Florida Power

Crystal River Unit 3

Subject: NRC Event #29062

SUBJECT: PR-95-0125, Corrective Item Step J - Design Basis Evaluation

Figure 1

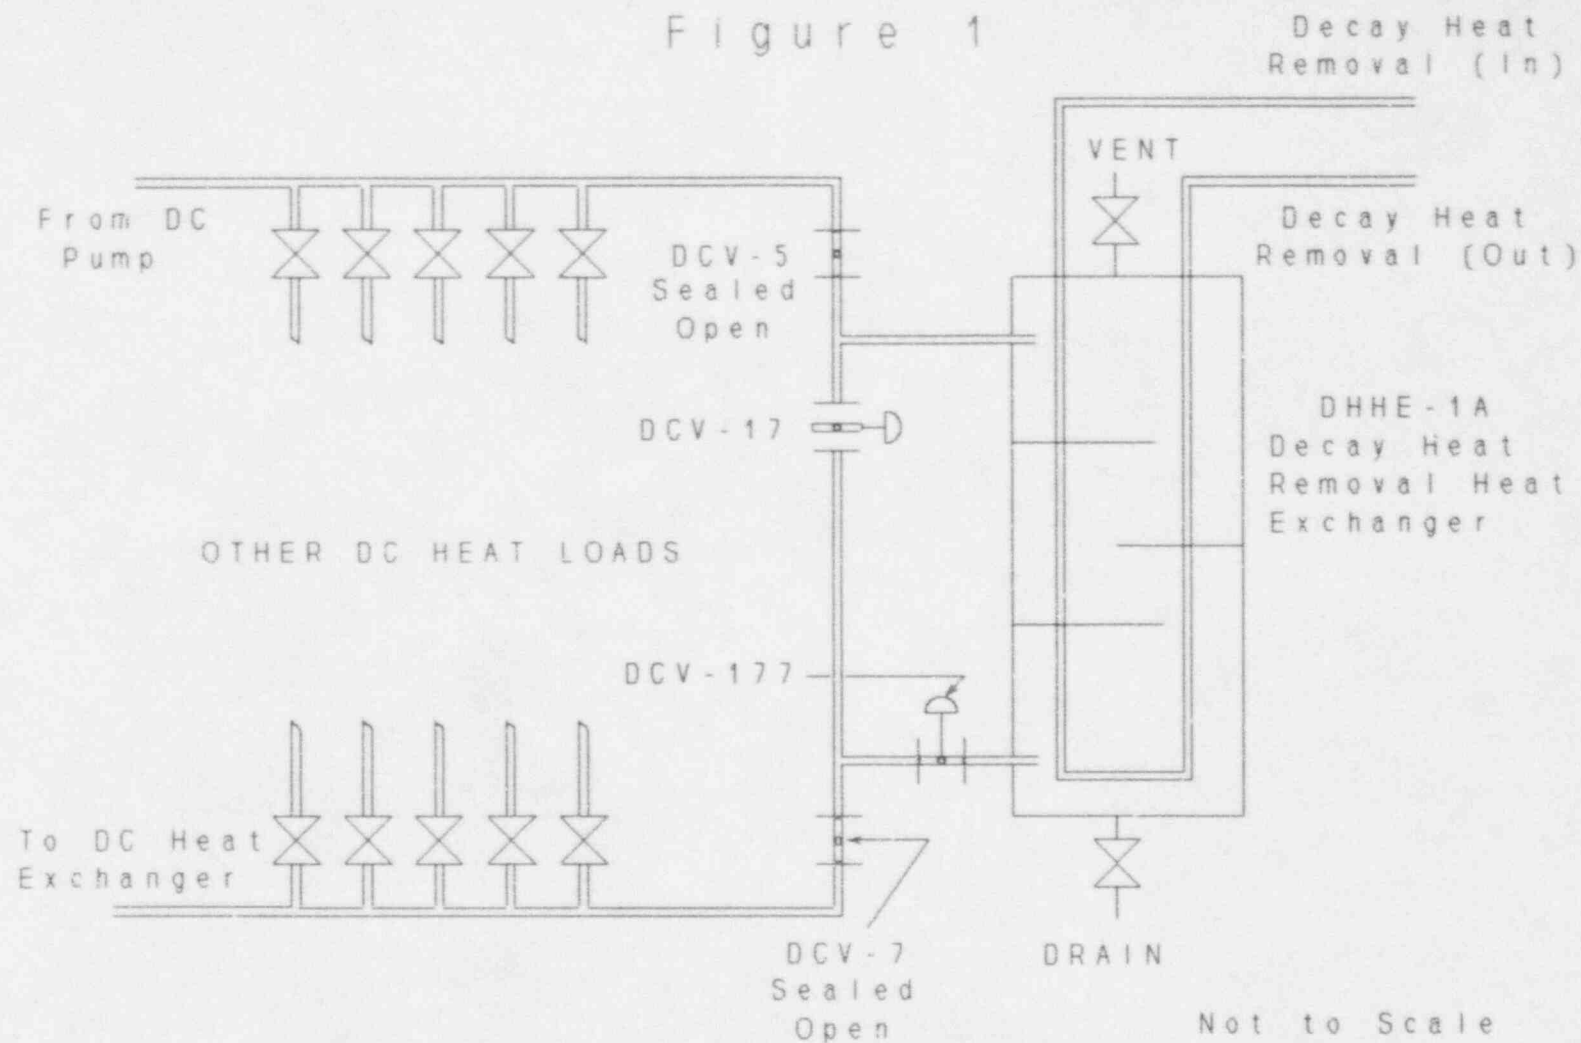
The condition reported to the NRC comprised the shell side of a decay heat exchanger not having a relief valve for overpressure protection, if the cooling water was isolated from the heat exchanger (see Figure 1). Subsequently, a Design Basis Evaluation (NED95-0399) was performed which stated, in part, "The DC [ed. Decay Heat Closed Cycle Cooling System] and DH [ed. Decay Heat] heat exchangers are designed in accordance with applicable design basis codes, standards, and regulatory requirements and are acceptable 'as designed'" (see Attachment 2).

Per flow diagram, FD-302-631, sheets 1 and 2 of 3, closure of DCV-5 and DCV-7 for DHHE-1A; and, closure of DCV-6 and DCV-8 for DHHE-1B would isolate these heat exchangers from the relief valves installed within the remainder of the DC piping system. During isolation of the heat exchangers, pressure relief would not be provided for these heat exchangers as required by the above referenced code requirements unless one of the two available vent valves were opened. Additionally, the existing pressure relief arrangement within the DC piping system, at first glance, does not appear to be in compliance with the above code requirements, as pressure relief capabilities located within the existing piping for DHHE-1A and DHHE-1B do not appear to be located between the existing isolation valves used for maintenance purposes for these heat exchangers, DCV-5 and DCV-7 for DHHE-1A; and, DCV-6 and DCV-8 for DHHE-1B.

During maintenance periods, when inlet and outlet isolation valves, DCV-5 and DCV-7 for DHHE-1A; and, DCV-6 and DCV-8 for DHHE-1B, for these heat exchangers may be closed for performing maintenance on the DC or DH side of these heat exchangers, one of the two available heat exchanger vents must be opened, as a minimum, to prevent any potential for inadvertent over pressurization of the isolated heat exchanger due to thermal transfer from the remainder of the DC System piping or the heat within the tube bundles from the DH System. This should occur whether the tube side has been isolated or not. Vents and drains are provided at the heat exchangers and must be used for this purpose.

the isolation valves DCV-5 and DCV-7 for DHHE-1A and DCV-6 and DCV-8 for DHHE-1B, is not a design basis issue. The DC System and the DH heat exchangers are designed in accordance with applicable design basis codes, standards, and regulatory requirements and are acceptable "as designed".

No further action is required for this issue. The Corrective Action Plan for this problem report is not needed nor required and will not be developed per this correspondence. We recommend voiding PR95-0125 and retraction of the NRC report generated for PR 95-1025.
